# Access Compliance Report

## Public Rights-of-Way

### (Curb Ramps)

Intersection ID: 11236	Main Street: N_CHURCH_ST	Cross Street: W_LIDDELL_ST	Location: S
ADA ID: 2492F6872CA8	Ramp Type: ParaDiag	Initial Pass/Fail: Fail	Overall Compliance: No
Codes/Mitigation Info/Possible Solution		Field Measurements/Component Compliance	
Severity Score: 28.75

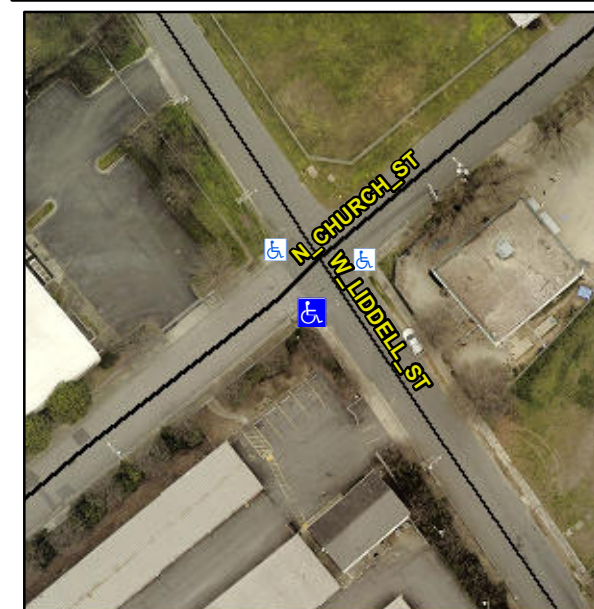
**DAMAGED RT RAMP**

**R304.5.3, R304.3.2, R302.7**

Compliance	Description	Data	Compliance	Description	Data
N/A	Ramp Length LT (in)	73.5	N/A	Ramp Length RT (in)	60.5
Yes	Ramp Width LT (in)	71.5	Yes	Ramp Width RT (in)	59.5
Yes	Ramp Slope LT (%)	5.7	No	Ramp Slope RT (%)	9.8
No	Ramp XSlope LT (%)	3.2	Yes	Ramp XSlope RT (%)	0.3
N/A	Landing Length (in)	N/A	N/A	DWS Provided?	N/A
N/A	Landing Width (in)	N/A	N/A	DWS Contrast?	N/A
N/A	Landing Slope (%)	N/A	N/A	DWS Length (in)	N/A
N/A	Landing X Slope (%)	N/A	N/A	DWS Full Width?	N/A
N/A	Landing Curb? (Y/N)	N/A	N/A	DWS Offset (in)	N/A
N/A	Shared Landing?	N/A			
N/A	Gutter Ponding?	N/A	N/A	Gutter Slope (%)	N/A
N/A	Gutter Lip Ht (in)	N/A	N/A	Gutter X Slope (%)	N/A
N/A	Painted X Walk1?	No	N/A	Painted X Walk2?	No
	X Walk 1 Direction	To NE		X Walk 2 Direction	To NW
N/A	X Walk 1 Width (in)	N/A	N/A	X Walk 2 Width (in)	N/A
	X Walk 1 Slope (%)	0.6		X Walk 2 Slope (%)	2.9
	X Walk 1 X Slope (%)	4.5		X Walk 2 X Slope (%)	1.0
N/A	Ramp inside XWalk1?	N/A	N/A	Ramp inside XWalk2?	N/A

**Remove & Replace Curb Ramp With Two New Directional Ramps or Equivalent.**
